ADDENDUM NO. 07

Date: 08.23.2024

**Westfield Washington School Corporation
Westfield Middle School West
Bid Package 02, BI:02 Building Concrete Work and BI:03 Steel and Railing Work
17707 Centennial Road,
Westfield, IN. 46074**

The Hagerman, Inc portion of this Addendum consists of the following information:

DRAWING NUMBER:
S202EFG

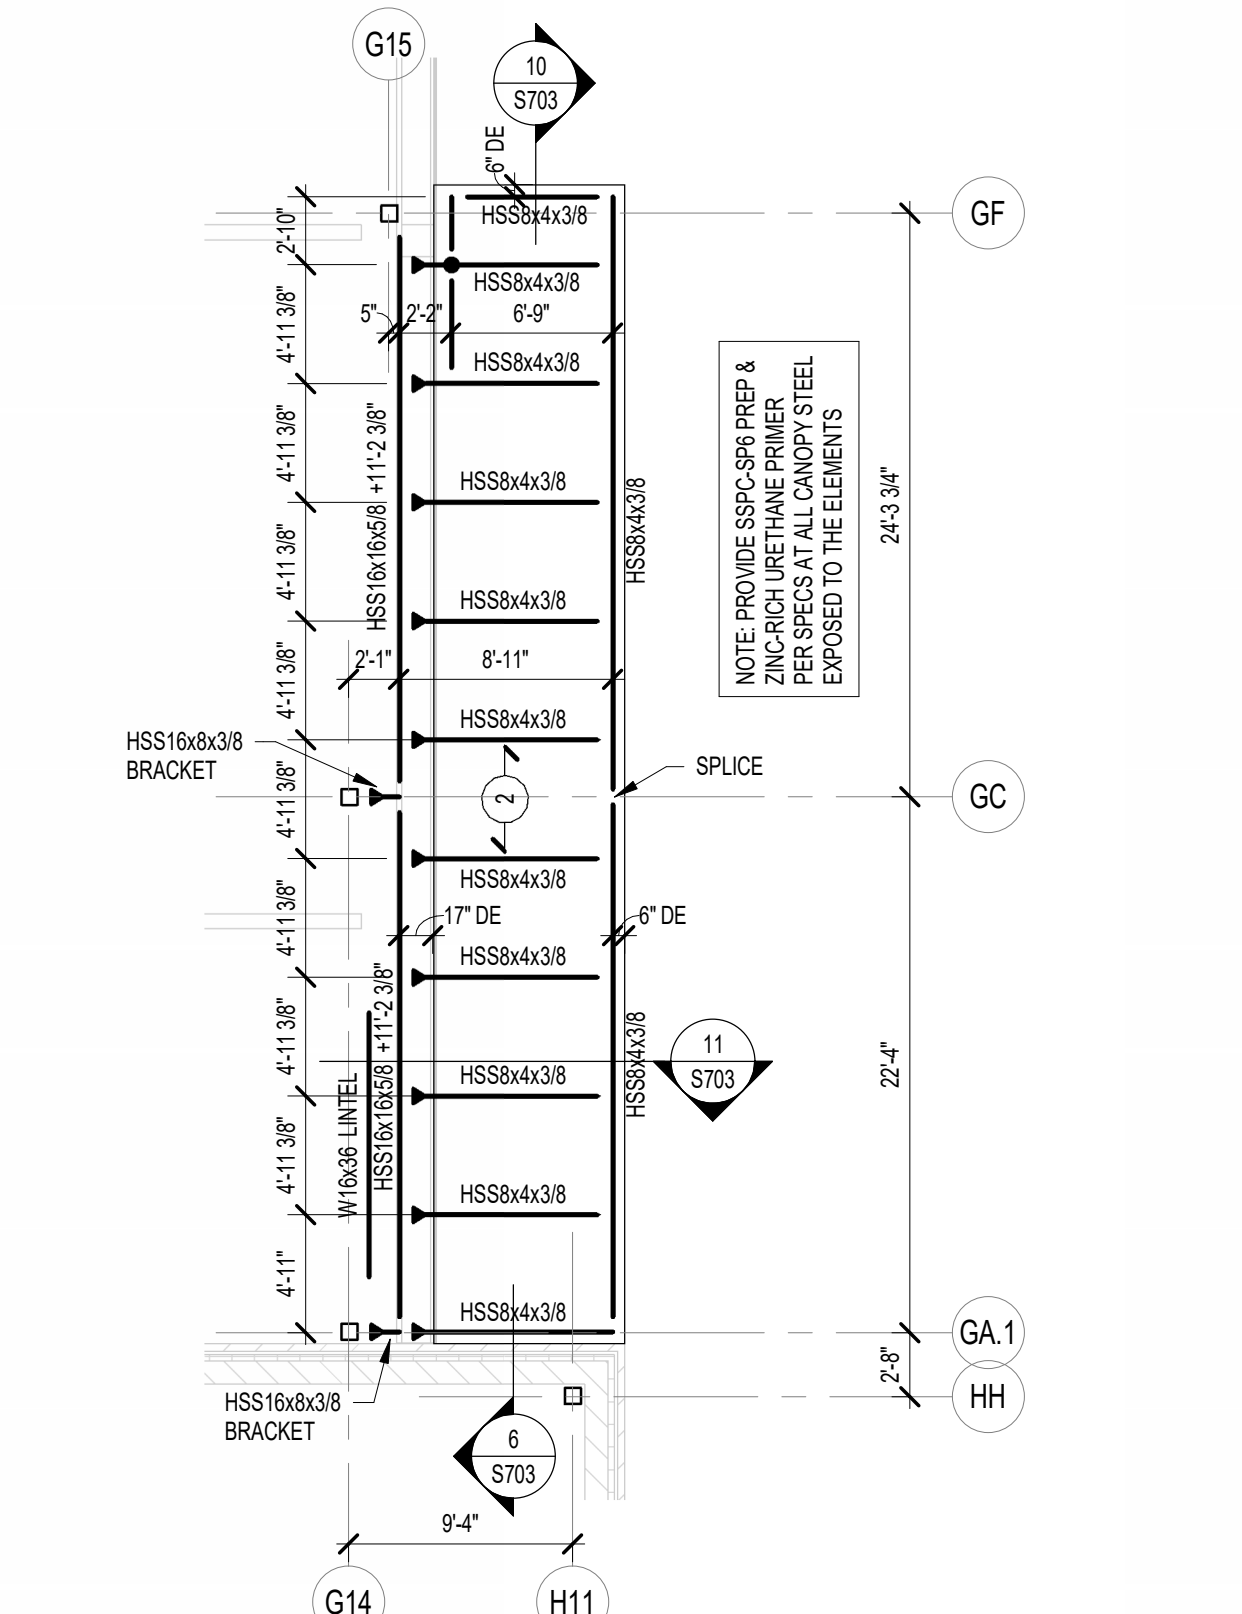
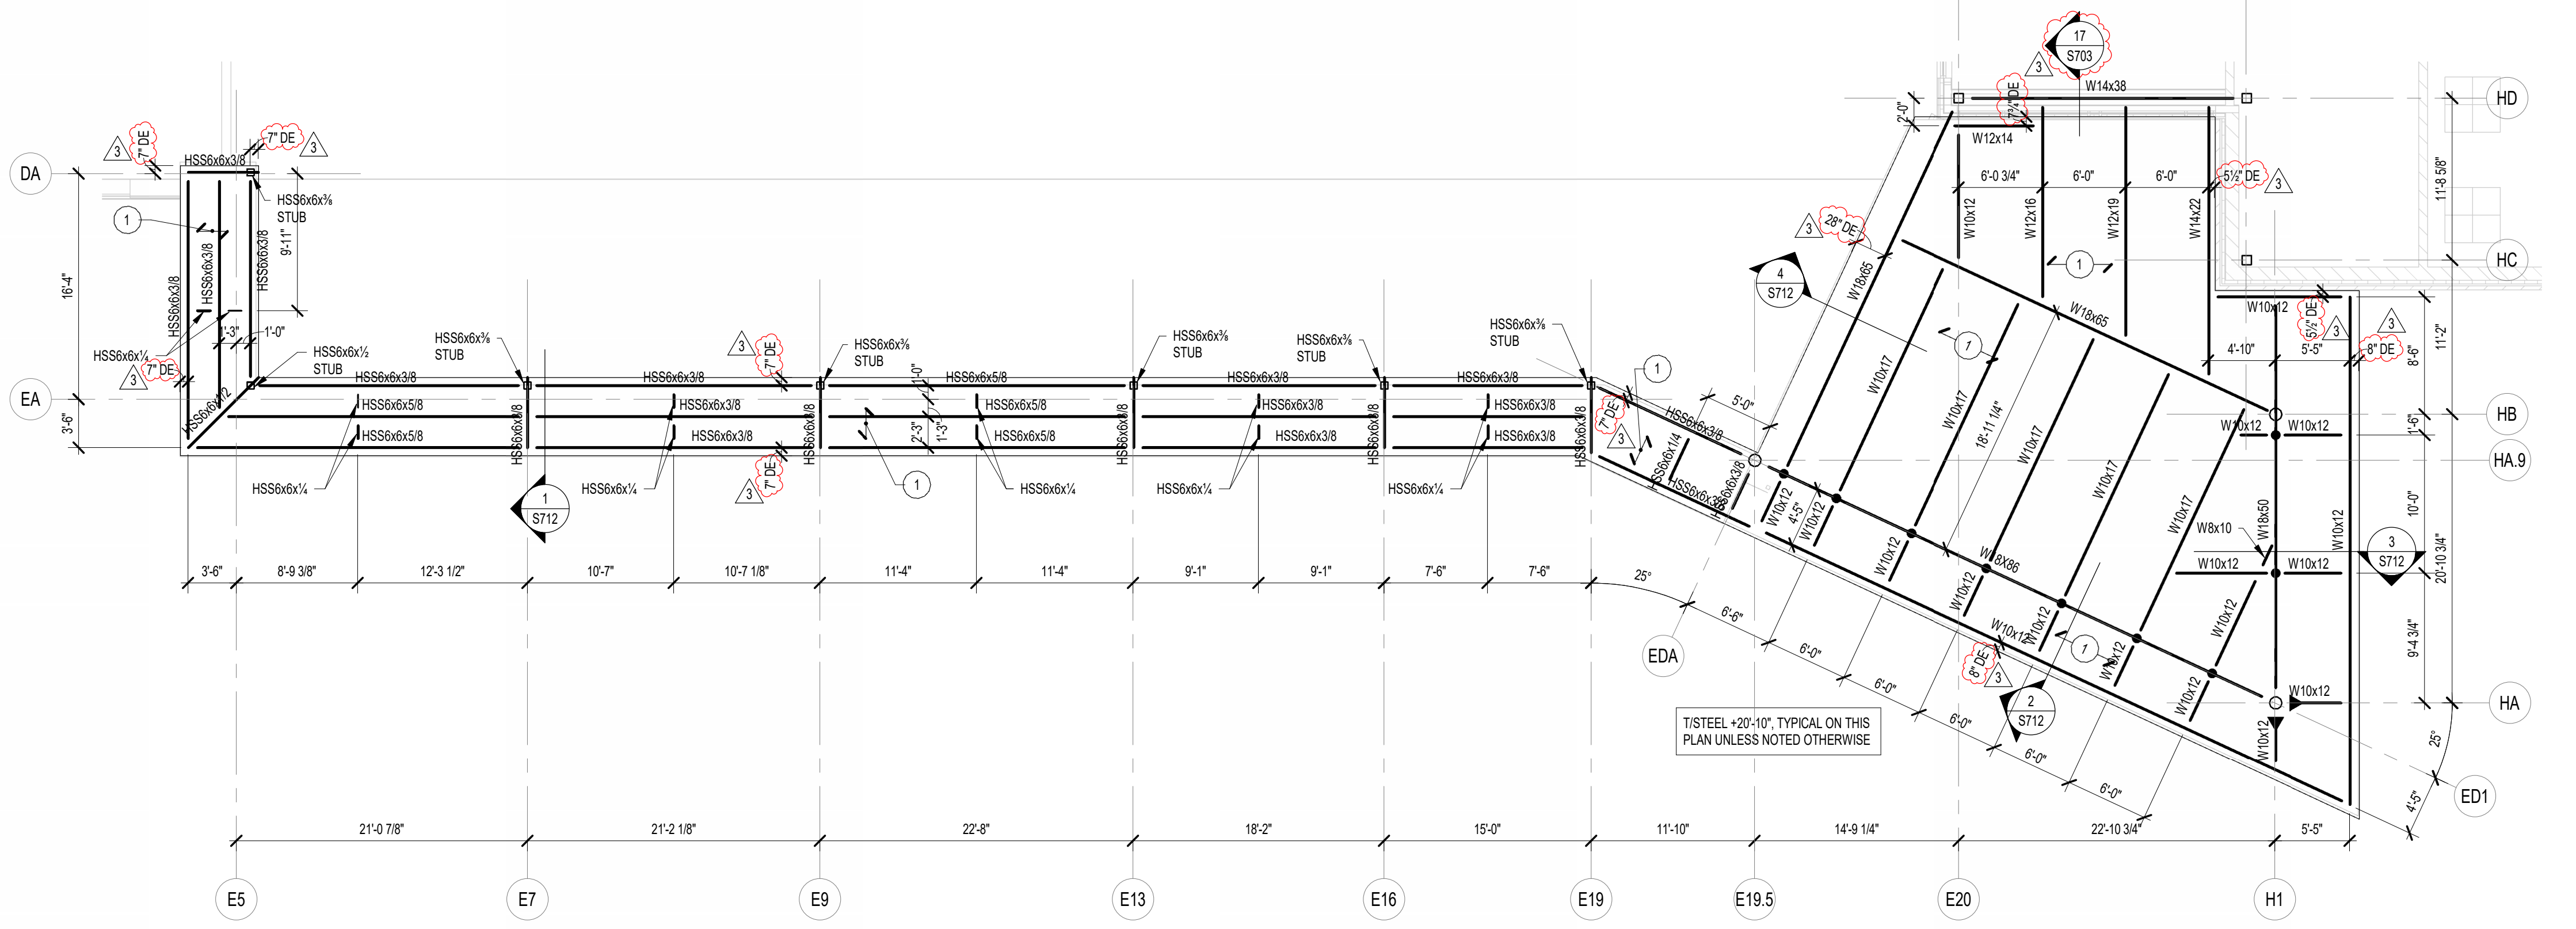
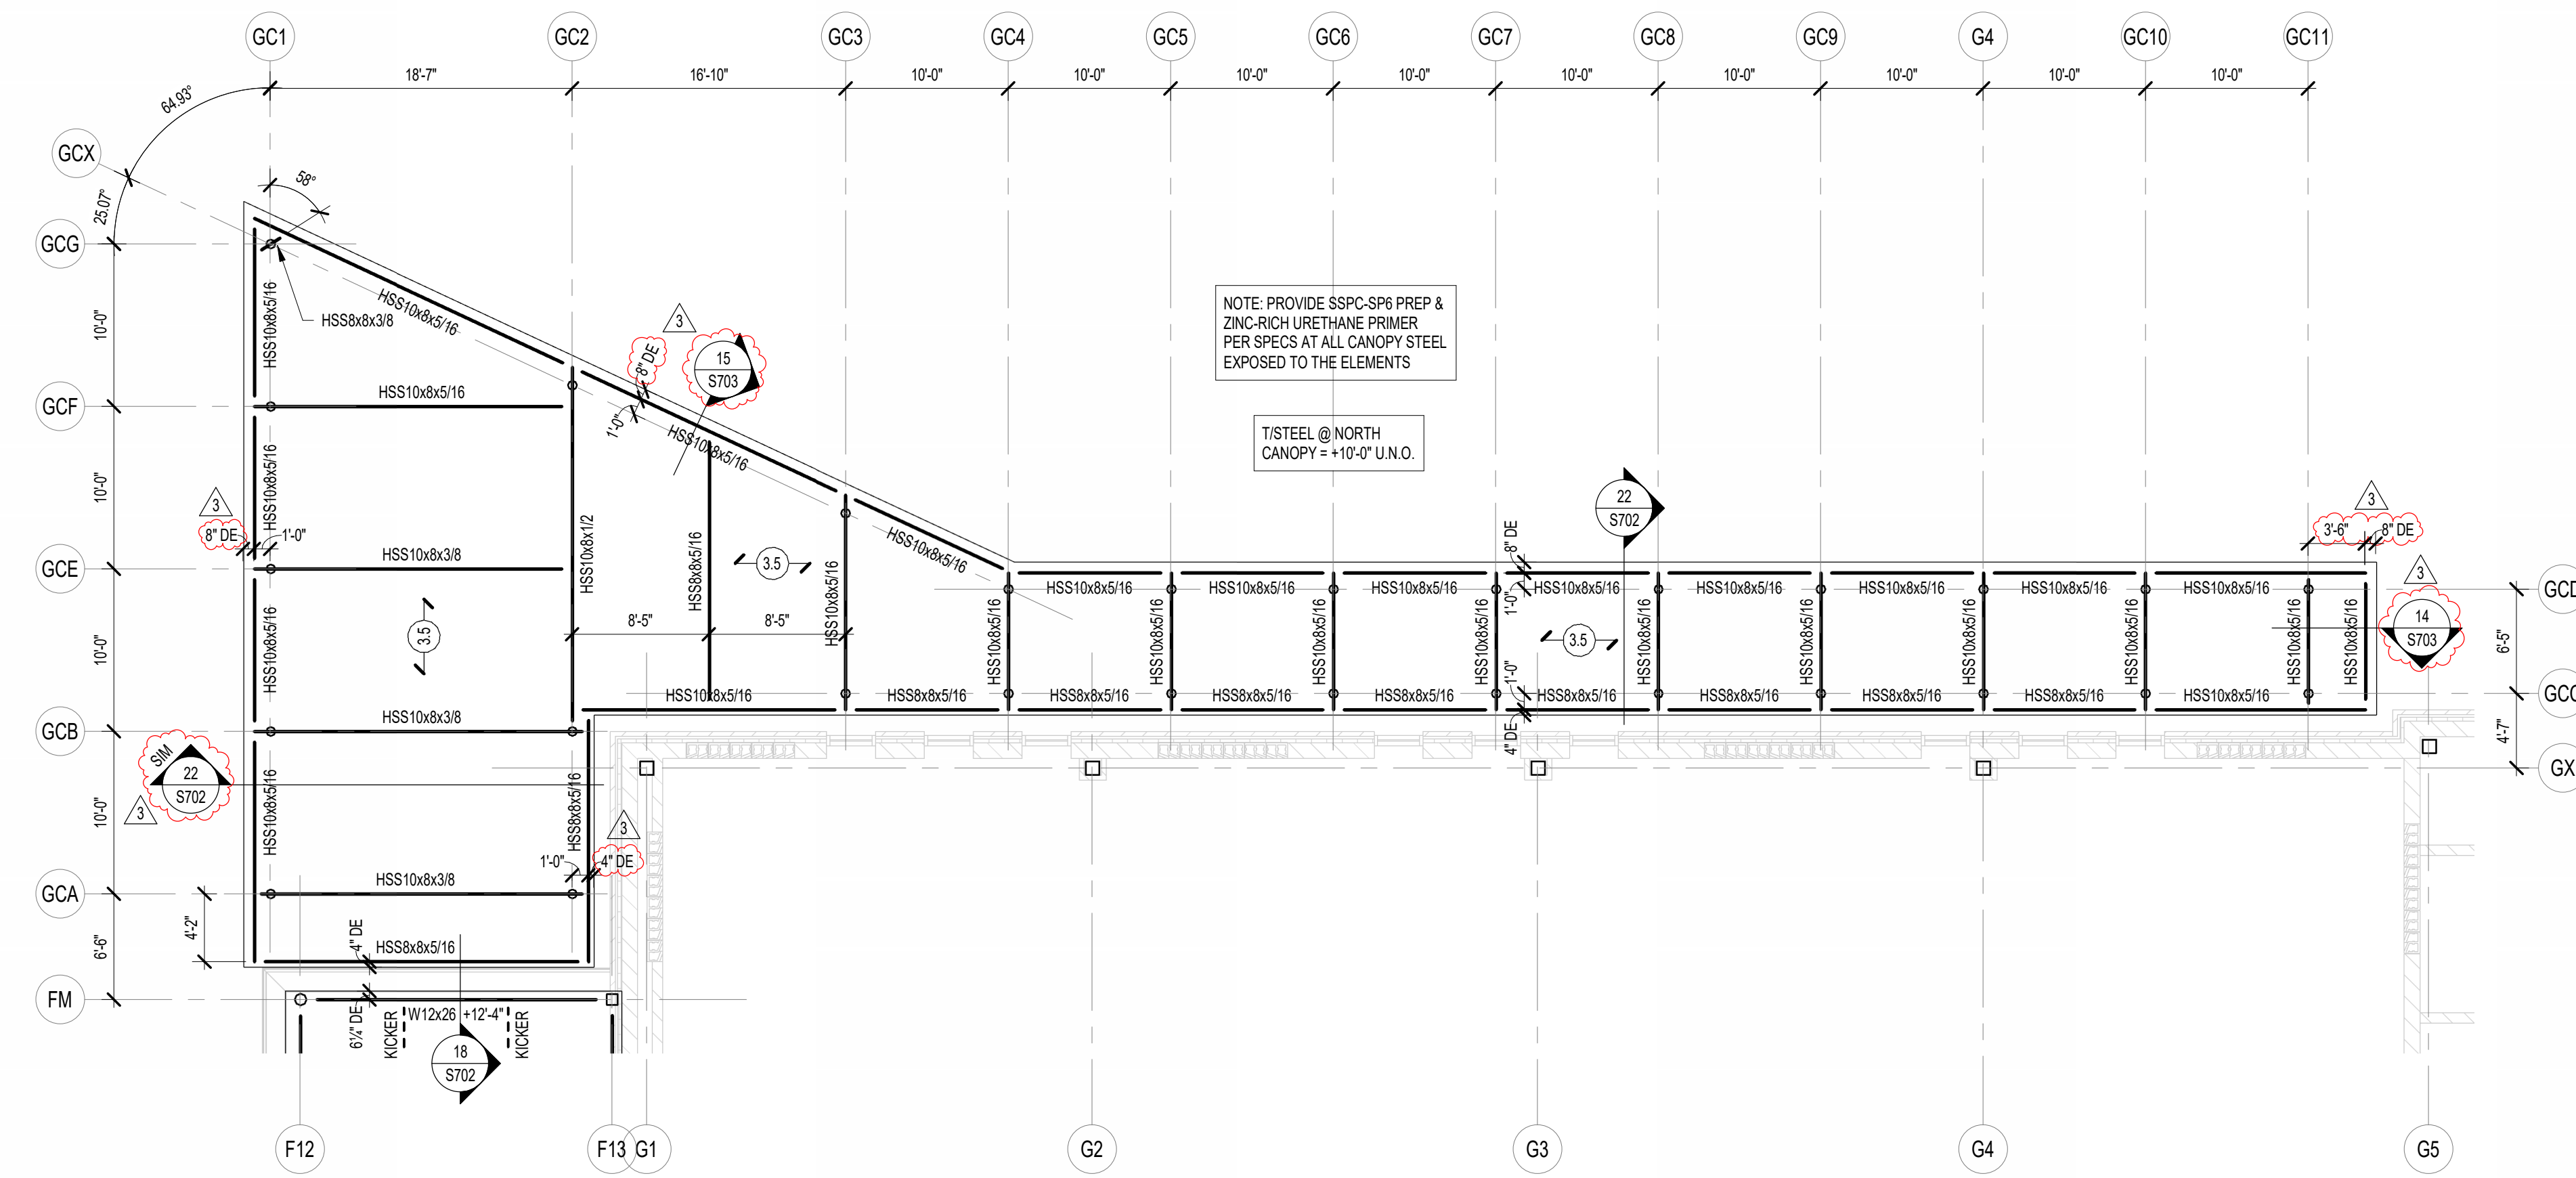
- A. 1/S202EFG: Add section callouts, deck edge dimensions, & revise framing layout dimension as shown.
- B. 2/S202EFG: Add deck edge dimensions and section callout as shown.

DRAWING NUMBER
S202F

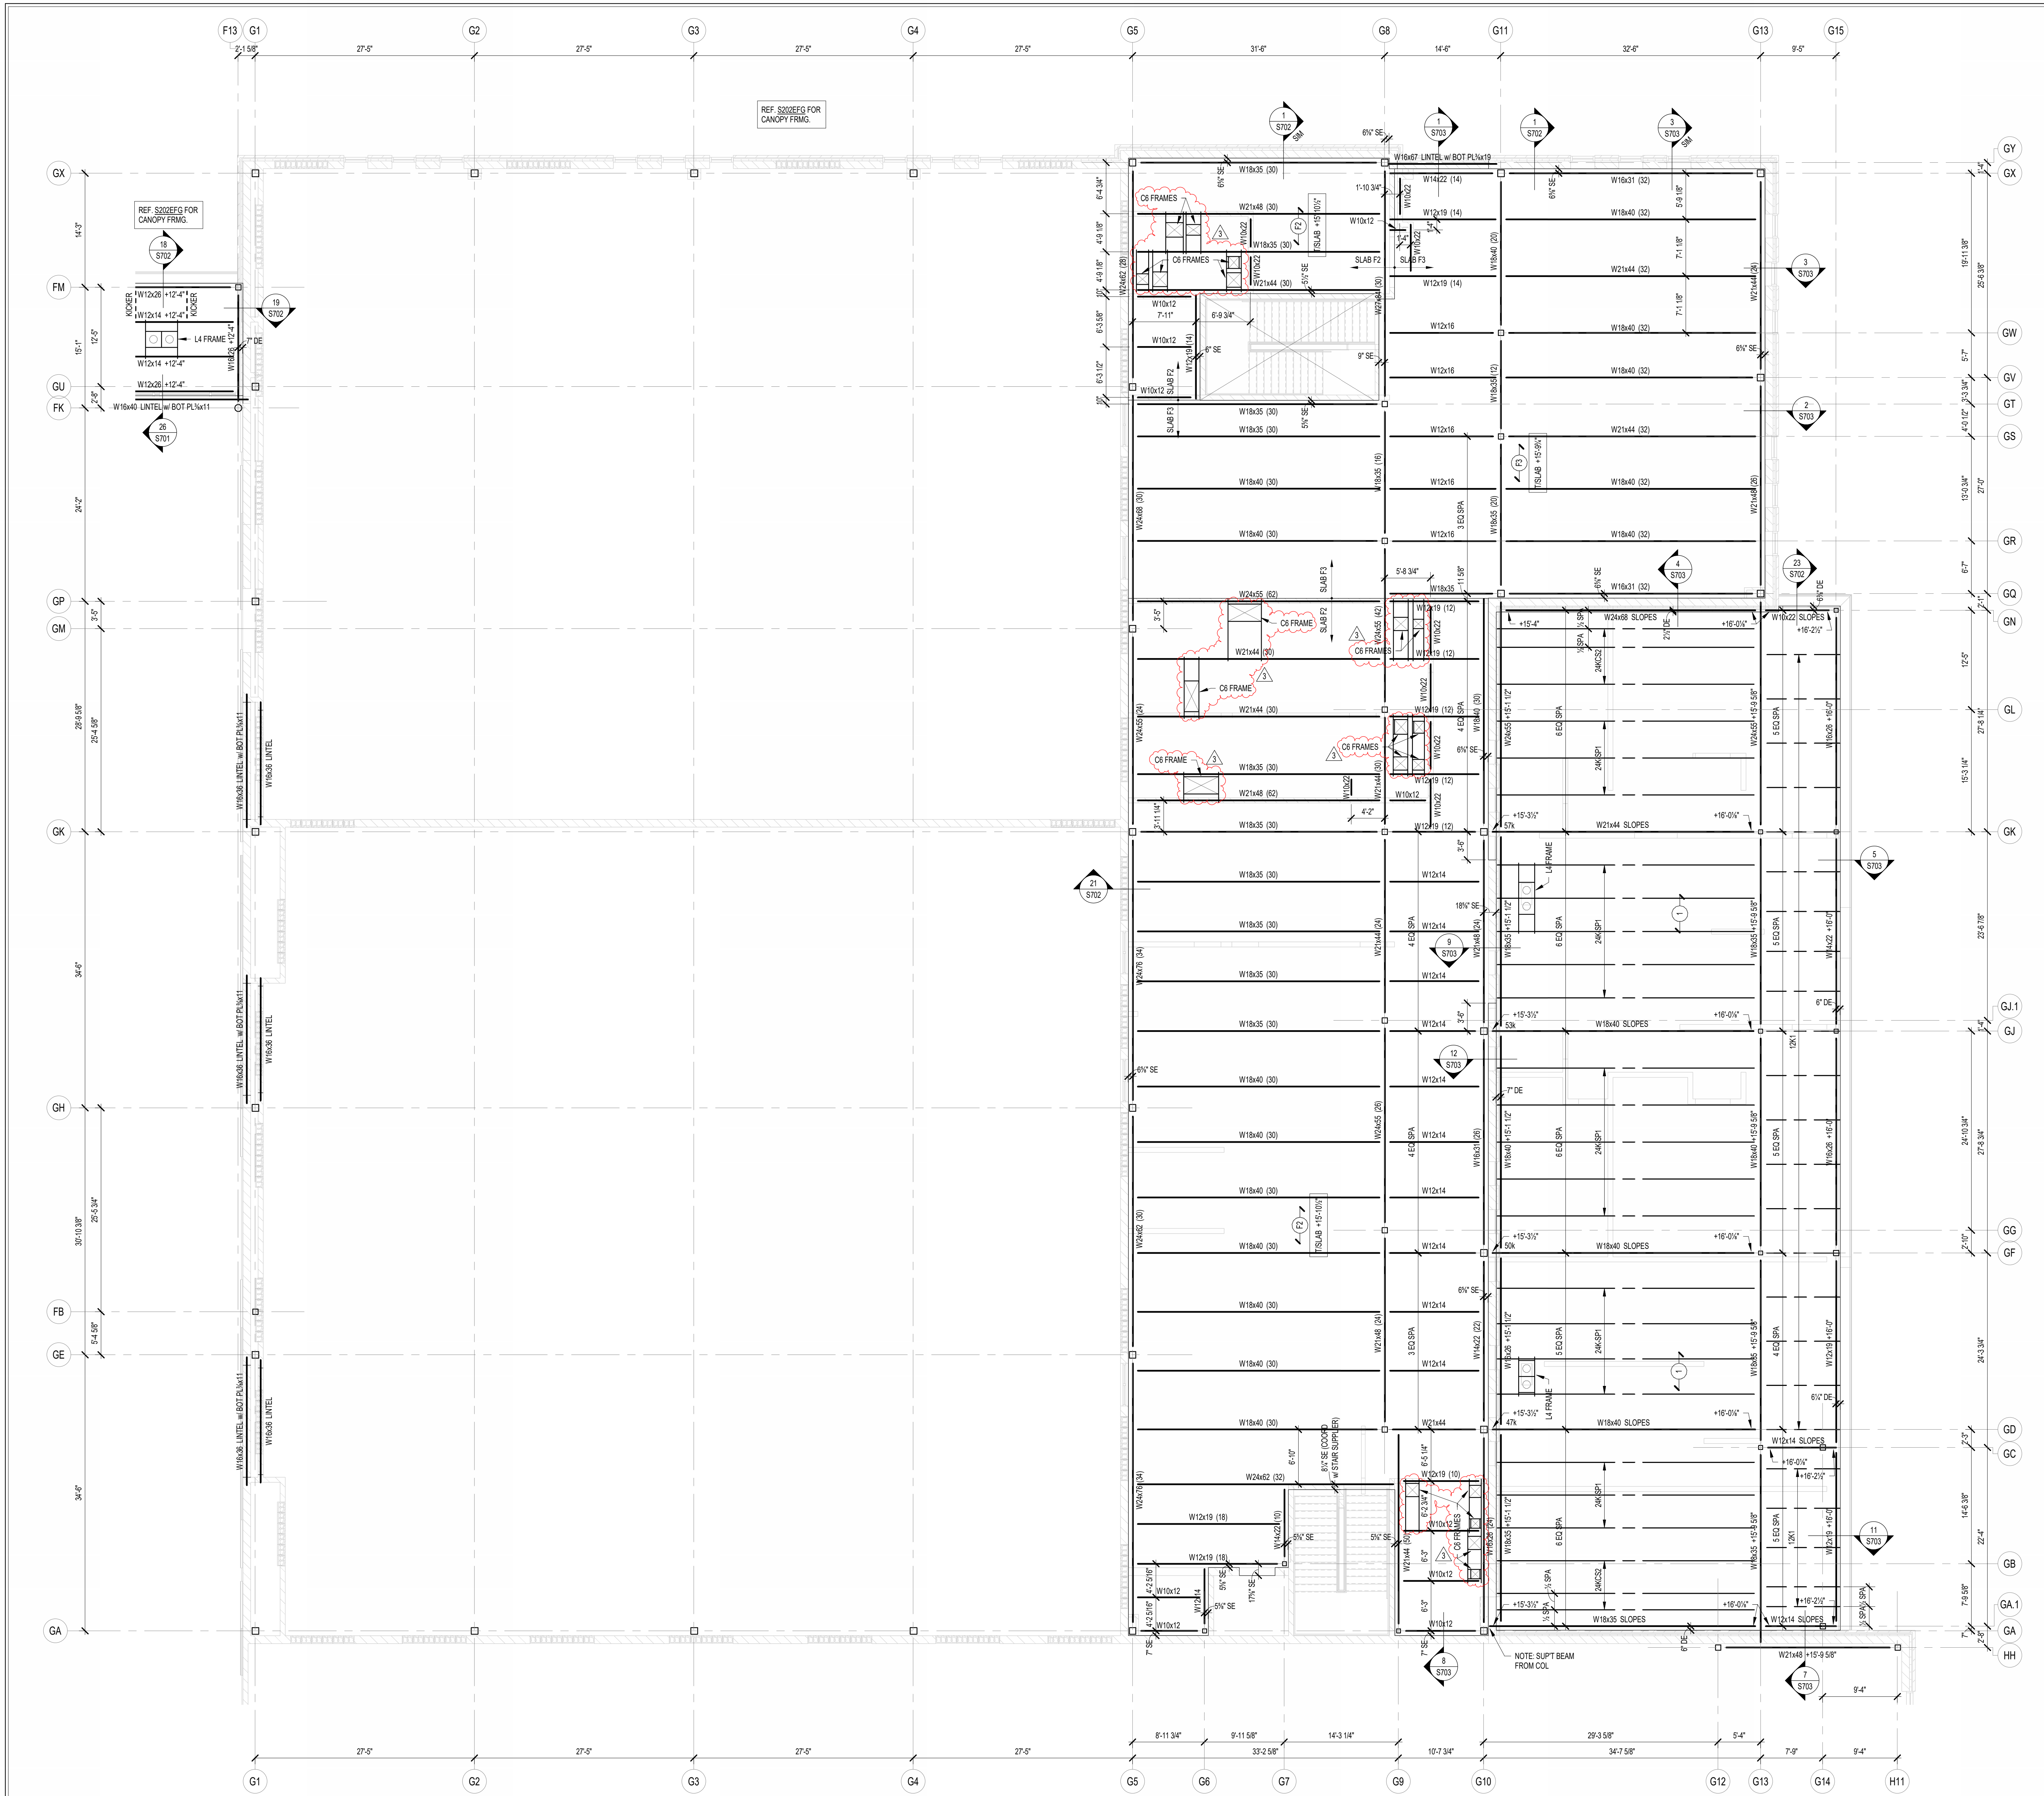
- A. Add floor and roof opening frames as shown.
